Addendum # 2 Bid 20-99433 Project: #1875 – Public Works & Utilities Building Roof Replacement

ADDENDUM No. 2

- A. Project Name: Public Works & Utilities Building Roof Replacement.
- B. Owner: City of Duluth, Minnesota.
- C. Architect: Benjamin Olson, AIA.
- D. Architect Project Number: 17790.000.
- E. Date of Addendum: June 29, 2020.

REFER TO GENERAL ROOFING NOTES ON SHEET A100 FOR ADDITIONAL INFORMATION

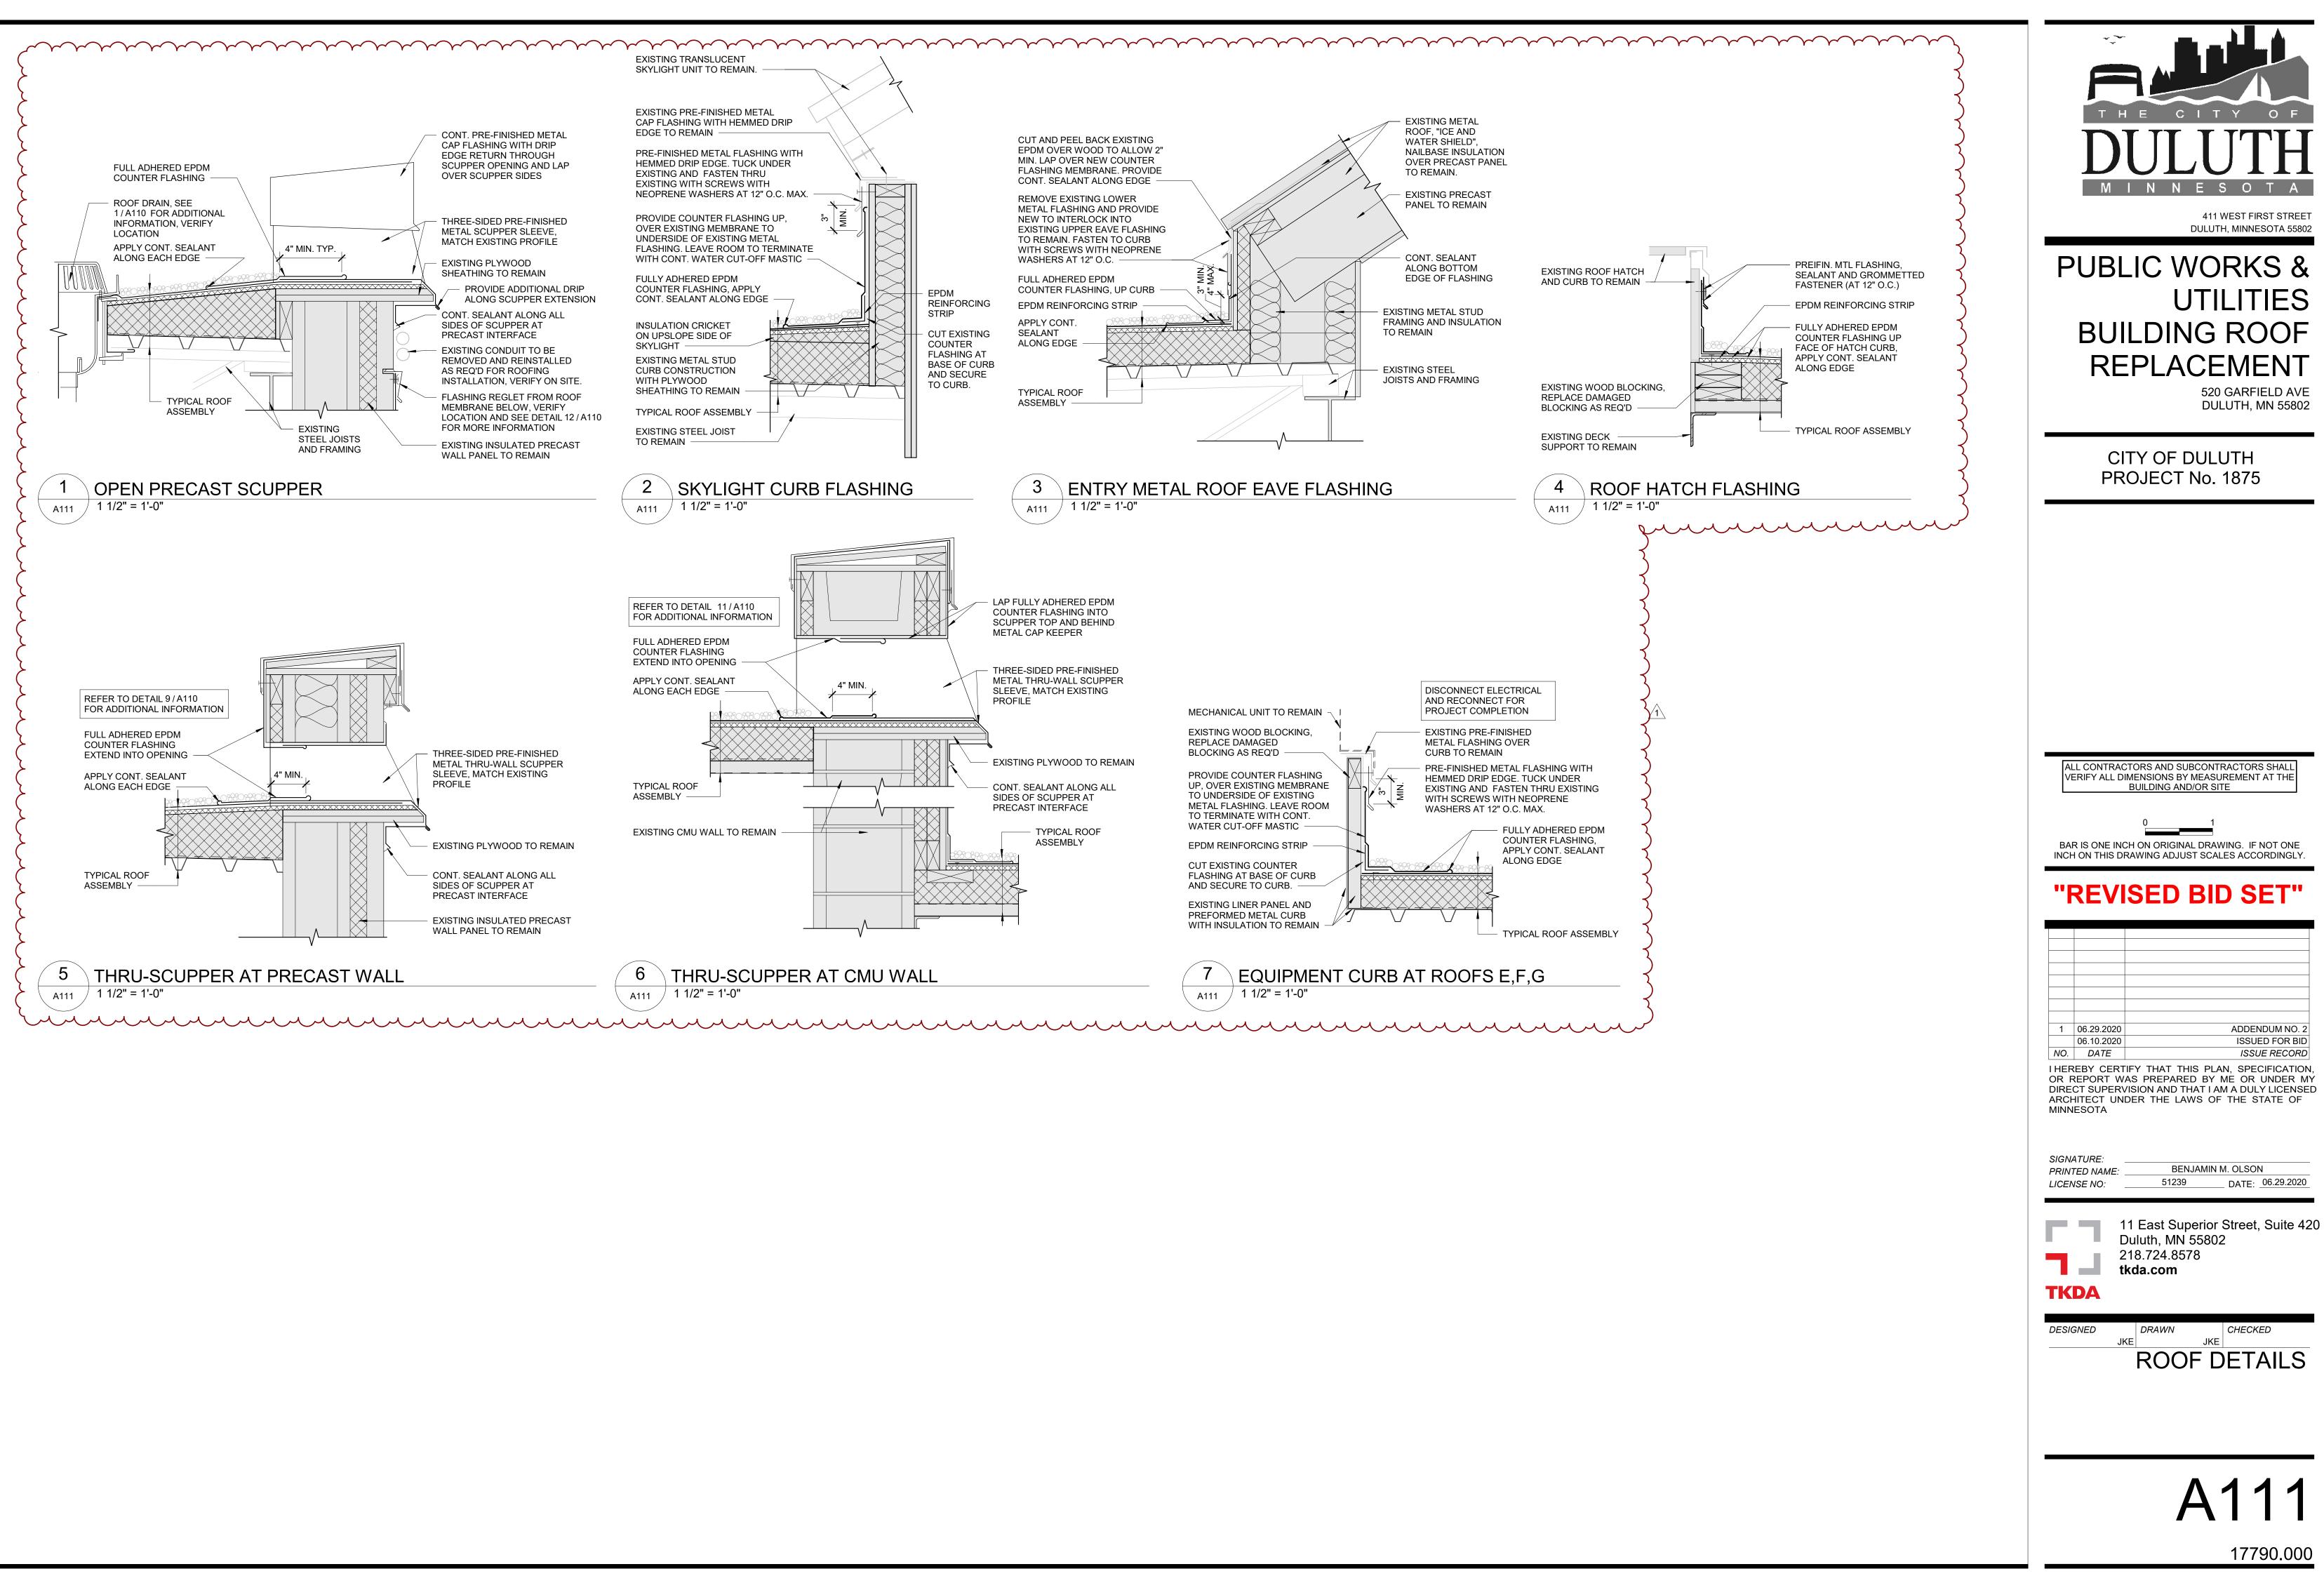
- C. Sheet A101 Enlarged Roof Plan, Roof Areas A, B, C & D (reissued only).
- D. Sheet A102 Enlarged Roof Plan, Roof Areas E & F (revised) (reissued).
 - 1. Changed reference detail in legend for mechanical unit to 7/A111.
- E. Sheet A110 Roof Details (revised) (reissued).
 - 1. Added 1/2 inch high density polyisocyanurate to details,
 - 2. Changed 2/A110 detail name to reference only roofs A,B,C, and D.
- F. Sheet A111 Roof Details (revised) (reissued).
 - 1. Added 1/2 inch high density polyisocyanurate to details.
 - 2. Changed 2/A111 to keep skylight installed during roof replacement.
 - 3. Added detail 7/A111 to keep mechanical unit installed on roofs E,F, and G during roof replacement.
